Handled by MSc. P (Paul) Telkamp Date November 25th, 2009 Reference N001-4615420PTK-V01

Quick evaluation pilot 3: UWWTP Kizilcahamam

Comments/questions of Illerbank with reference to N001-4615420PTK-V01 (date November 25th, 2009)

• Example 1: Integrating anaerobic tank with activated sludge tank in a circular reactor

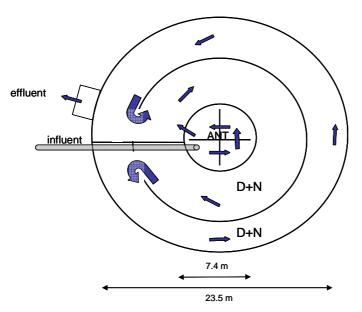
<u>Conclusion</u>: Based on a check in the Tauw calculation tool the volume and configuration choice is OK. Integrating the anaerobic tank with the activated sludge tank or integrating the settling tank with the activated sludge tank seems to be a logical improvement. See appendix 2 for some examples. In appendix 3 two build configurations of appendix 1 are visualised for the future location of UWWTP Kizilcahamam.

Based on the volumes and a depth of 5 m the total surface needed for the anaerobic tank + activated sludge tank is 433 m^2 . This results in a diameter of 23.5 m. The diameter of the anaerobic tank should be 7.4 m. The remaining surface is for the activated sludge tank.

• Example 3: Integrating settling tank with activated sludge tank in a circular reactor

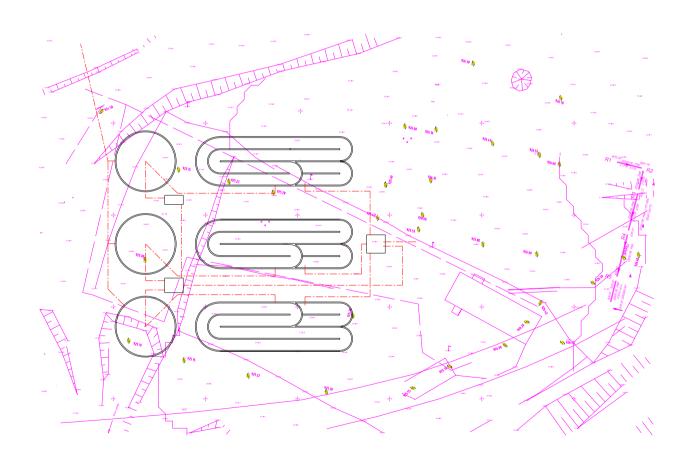
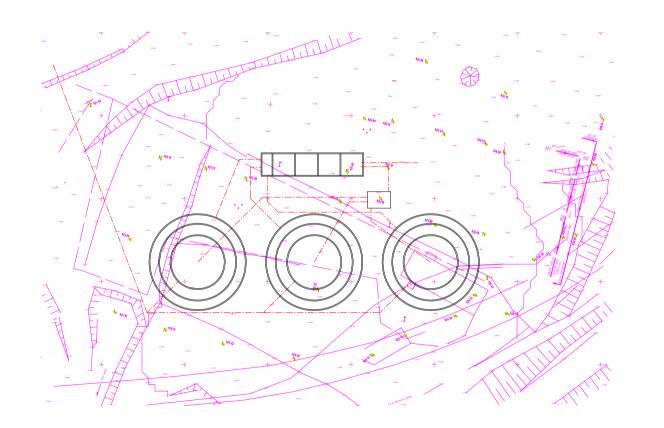
Based on the volumes and a depth of 5 m the surface needed for the activated sludge tank 390 m². The surface needed for the settling tank is 201 m². This results in a total diameter of 28 m. The diameter of the anaerobic tank should be 16 m. The remaining surface is for the activated sludge tank. The settling tank will keep its original depth. A point of interest is the width of the activated sludge tank in relation to the propulsors. The width of the outer two circles is 3 m while the depth is 5 m. Be sure that the propulsors can be installed properly to ensure a good rate of flow.
